Lower Thames Crossing Review - A Basic Error

LTC Planning Submission (1)

Plate 4.2 Traffic using the Dartford Crossing

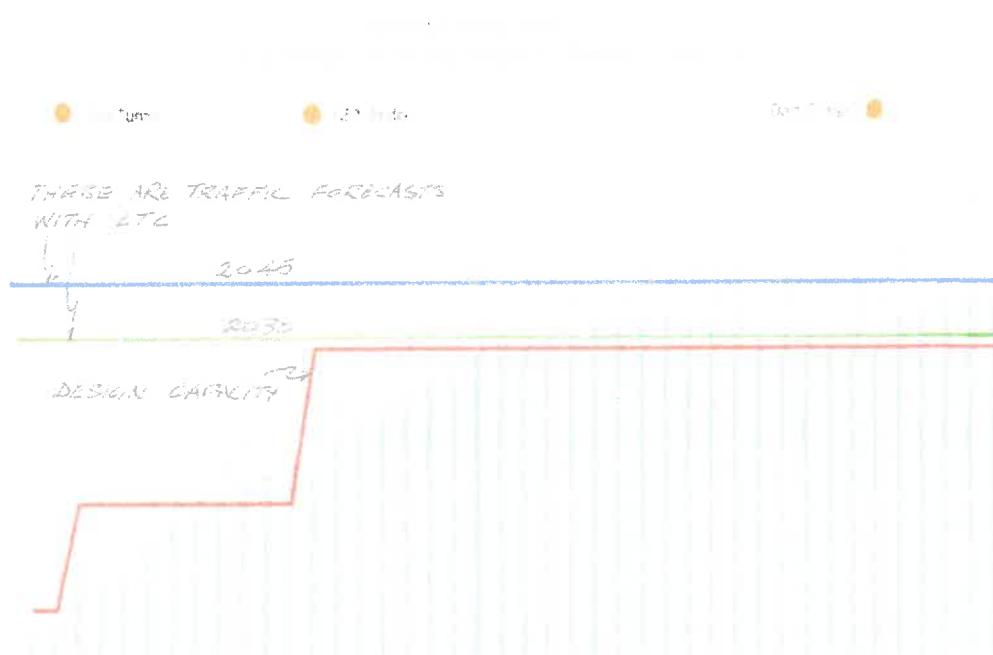
I have added to plate 4.2 indications of the forecast flows which will persist at the Dartford crossing even after the construction of the proposed Lower Thames Crossing.

It can be seen that the proposal totally fails in its intended purpose. All that is offered even after the vast intended expenditure is a situation where the forecast flows in both 2030 and 2045 at the Dartford crossing remain well in excess of the designed capacity there.

Chart G.2: The effect of tunnel length on unit costs

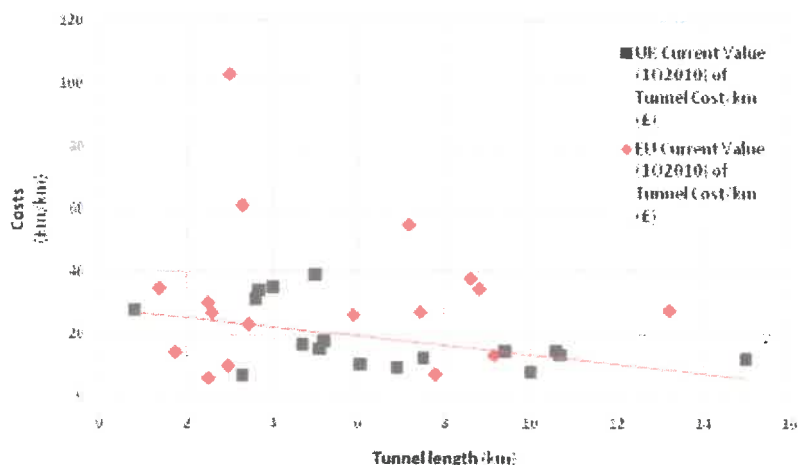
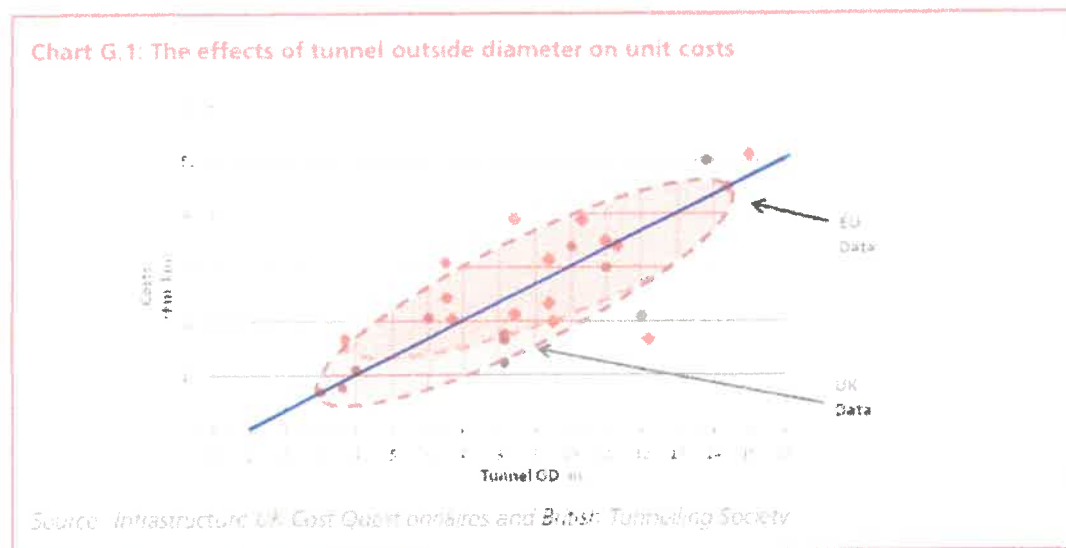
The blue line is an addition of mine. The following diagram traces the inflationary increases in construction costs (blue line).

I use these 3 diagrams in updating and adjusting the costs of previously implemented tunnelling projects to give a guide to the cost of A14 in 2022.
